RICHCRAFT TERRACE FLATS, CRT LANDS (BLOCK 344)

FUNCTIONAL SERVICING REPORT

MAY 03, 2022

PROJECT NO.: 211-01221-00
CLIENT REF: N/A
DATE: MAY 03, 2022
VERSION: 03

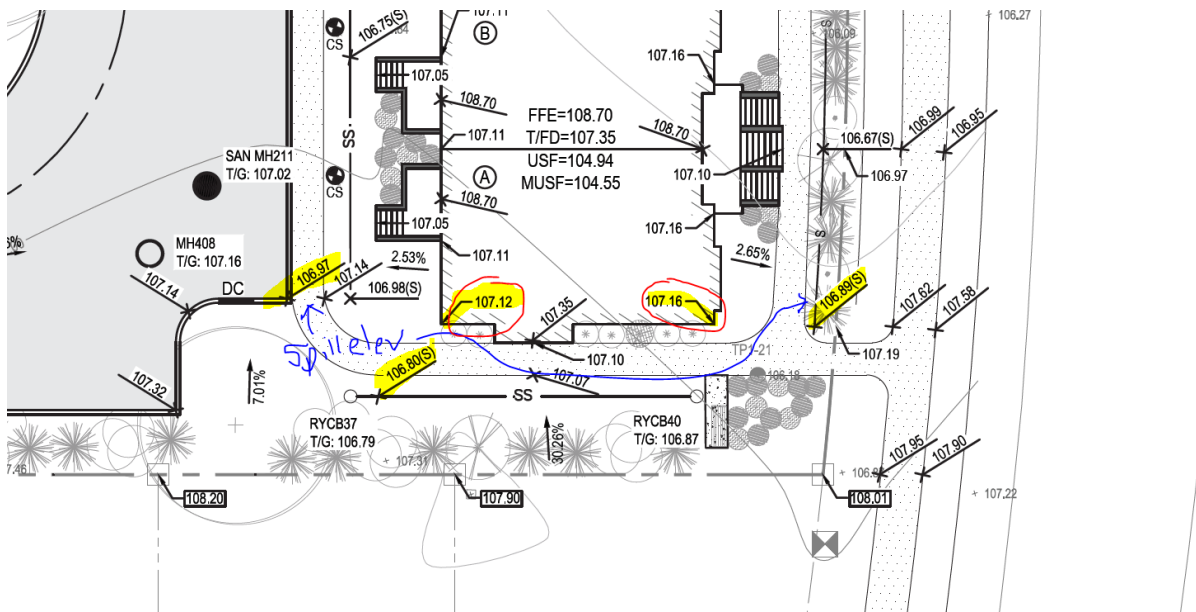
31. Incorrect address is shown (5725 Fernbank Road) on this report? Please review and revise.

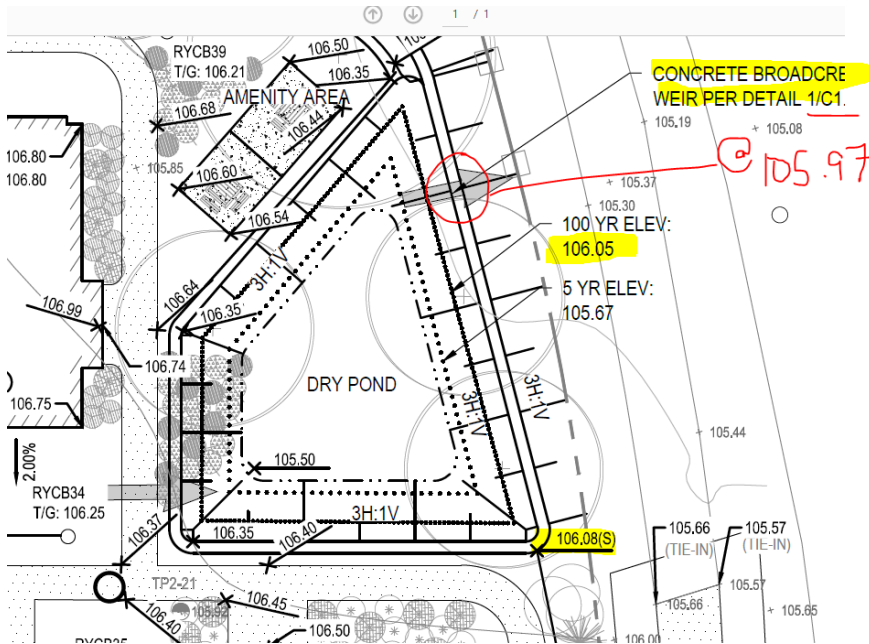
- 35. Please update the grading plan for all ponding areas, including RY swales (not modelled with storage), to identify all high points/spill elevations and major overland flow/emergency overland flow arrows. Please ensure that the “RY” swale grading meets PIEDTB 2016-01. In particular, per PIEDTB 2016-01: *“The maximum depth of flow depth in rear yards is 300 mm. Furthermore, there must be at least 30 cm of vertical clearance between the rear yard spill elevation and the ground elevation at the adjacent building envelope.”* For example, please see the marked up grading plan below where it does not appear that vertical clearances have been met. Please revise.

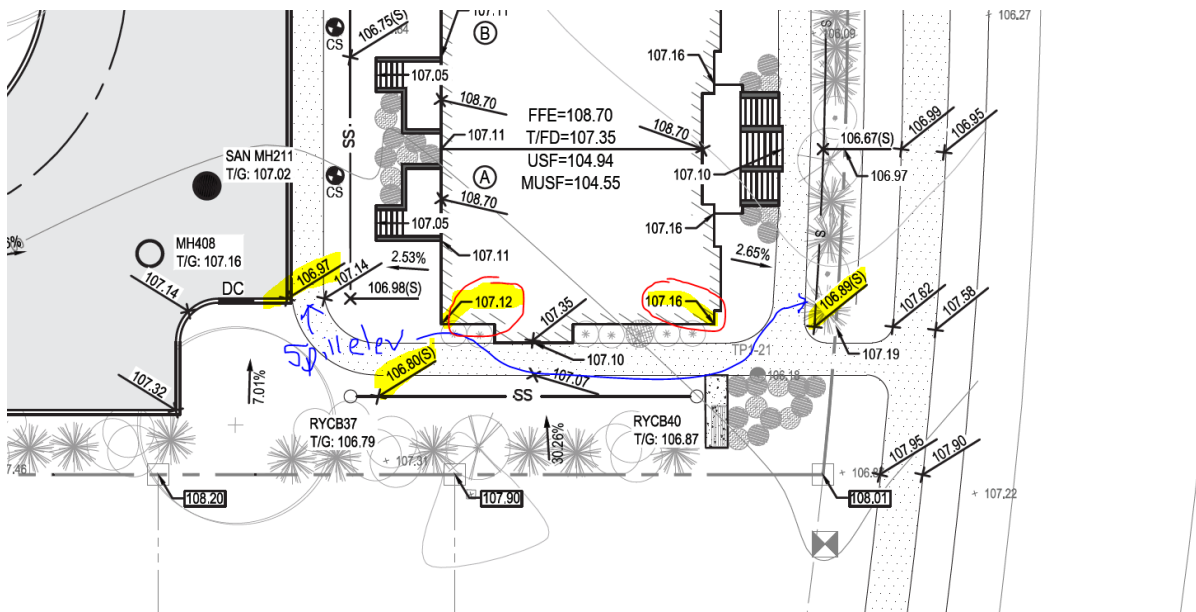
31. Incorrect address is shown (5725 Fernbank Road) on this report? Please review and revise.

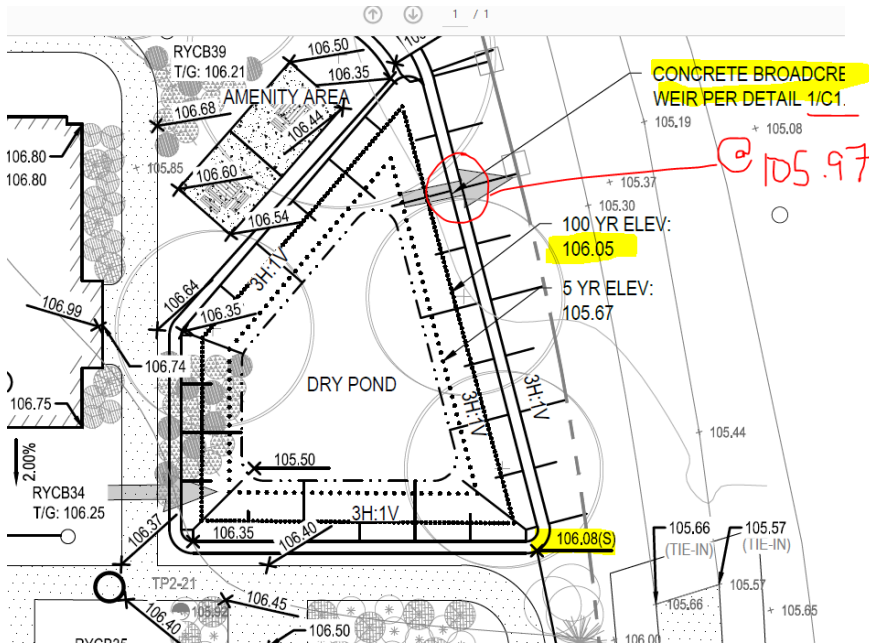
- 35. Please update the grading plan for all ponding areas, including RY swales (not modelled with storage), to identify all high points/spill elevations and major overland flow/emergency overland flow arrows. Please ensure that the “RY” swale grading meets PIEDTB 2016-01. In particular, per PIEDTB 2016-01: *“The maximum depth of flow depth in rear yards is 300 mm. Furthermore, there must be at least 30 cm of vertical clearance between the rear yard spill elevation and the ground elevation at the adjacent building envelope.”* For example, please see the marked up grading plan below where it does not appear that vertical clearances have been met. Please revise.
